Wisconsin Department of Transportation

Proposal #27: 6125-02-71, WISC 2026149
STH 29 – CTH J
N Br Embarrass River Br B-58-0139
CTH D
Shawano County

This is Addendum No. 01, which provides for the following:

ADDENDUM NO. 01

SHEET 2 OF 14

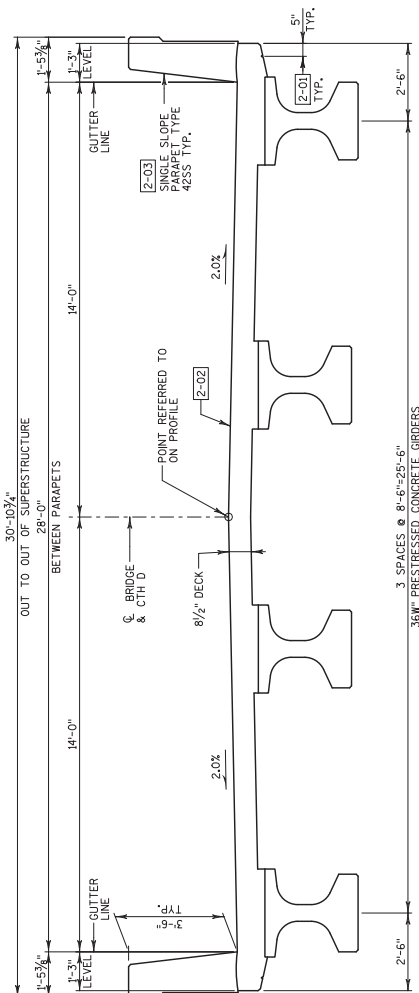
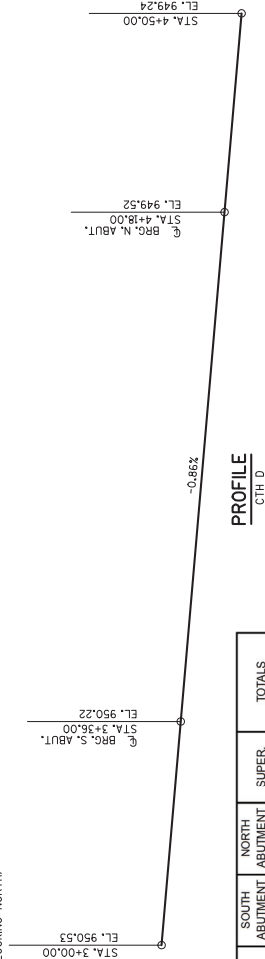
Revised Plan Sheets	
Plan Sheet	Plan Sheet Title (brief description of changes to sheet)
77	Sheet 2 of B-58-139 plans – removed the bid item in the 19th row of the “Total Estimated Quantities” table (Bid Item Number SPV.0180) and replaced it with Bid Item Number SPV.0195. Column entries for the South Abutment and North Abutment were changed from “144” and “139” to “45” and “43” respectively. The “Totals” column was changed from “283” to “88”.

614.0150	ANCHOR ASSEMBLIES FOR STEEL PLATE BEAM GUARD	EACH	2	2	—	4
645.0111	GEOTEXTILE TYPE DF SCHEDULE A	SY	30	30	—	60
645.0120	GEOTEXTILE TYPE HR	SY	165	160	—	325
SPV 0195	INFILL RRPAIP - B-58-139	TON	45	43	—	88
	NON-BID ITEMS					
	FILLER	SIZE	—	—	—	112' & 3/4"
